CCD1: Construction Code Determination Form

Re: 550 West 34th Street aka 55 Hudson Yards, Manhattan

ZRD1/CCD1 Response Form

Z-005.00
0.5 mg / 500 mg

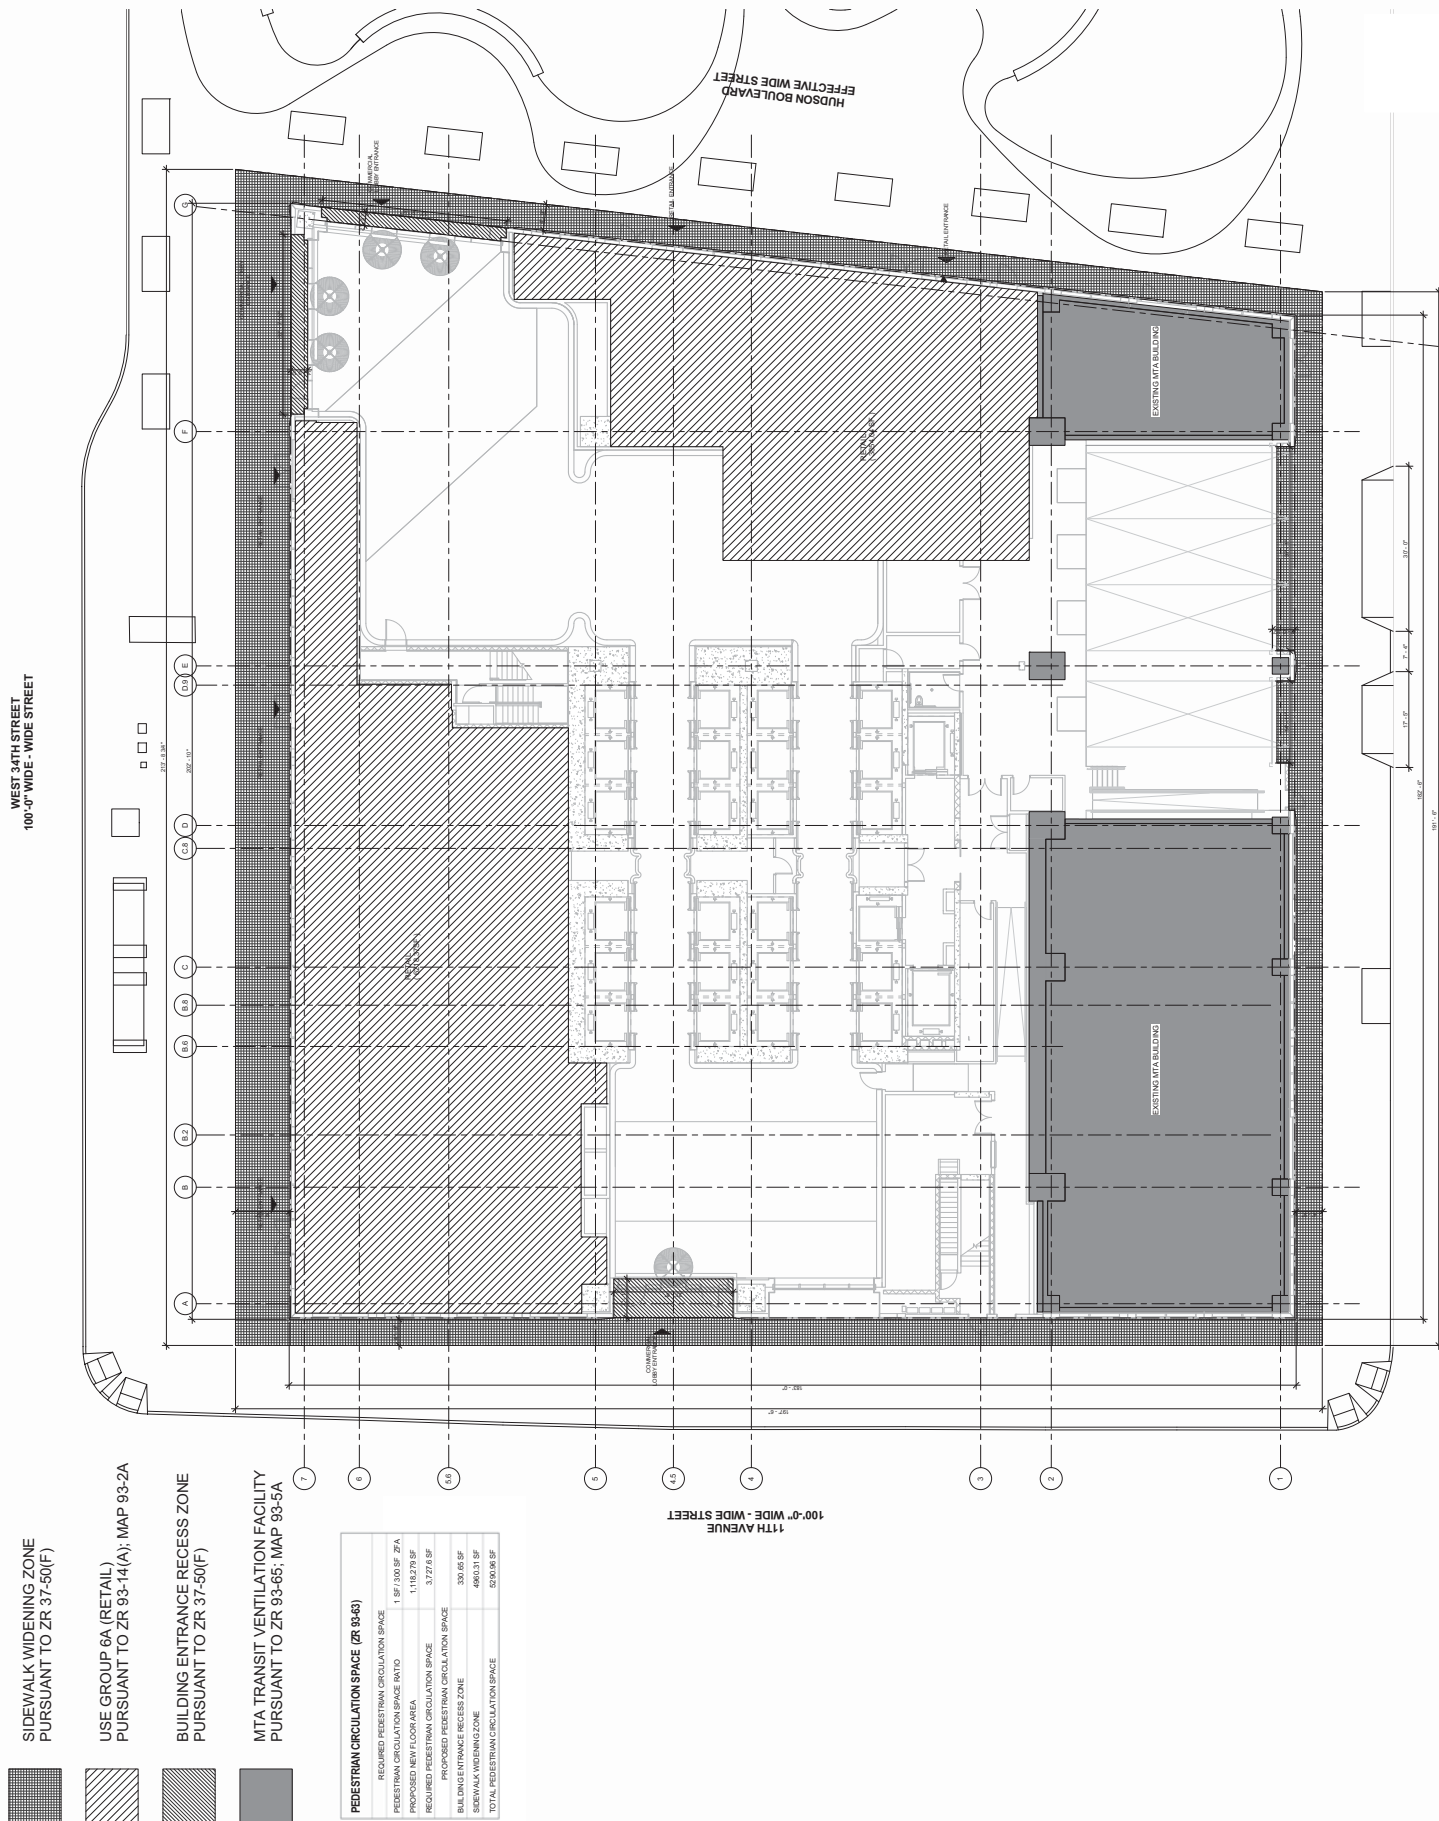
The proposed layout includes two curb cuts, measuring 17.4-ft and 41.5-ft long, with a 3-ft long full-height curb separating the two. The sidewalk is approximately 18-ft wide in this area (5-ft building setback and 13-ft public sidewalk). Refer to attached CSK-22 for proposed layout.

The request that two curb cuts, measuring 17.4 ft. and 41.5 ft. in width, including splays, which accesses accessory off-street loading berths located within a building are not subject to the Building Code provisions for curb cuts accessing open parking lots is hereby approved with conditions.

provisions in ZR 13-30, including ZR 13-31 (Modifications of Minimum Size of Loading Berth). The dimensions of the proposed loading berths are not shown in the submitted plans; as such, the allowable floor area deductions for the loading berths cannot be ascertained.

- (1) Plans demonstrate that all accessory off-street loading berths accessed by the two curb cuts, measuring 17.4 ft. and 41.5 ft. in width, including splays, are enclosed within a building;

- (2) Plans filed with New Building application No. 121184841 (e.g., Dwg. Nos. Z-005.00 and Z-102.00, etc.) are amended to show four proposed accessory enclosed off-street loading berths and the Schedule A form is amended to indicate a total of four proposed accessory off-street loading berths located in the first story;

- (5) The Builders Pavement Plan ("BPP"), filed under the permitted Alteration Type III application No. 140254784, is amended to match the size and layout of the two proposed curb cuts shown in New Building application No. 121184841 and as described above; and

Therefore, the above stated request is hereby approved provided the borough plan examiner verifies the following conditions:
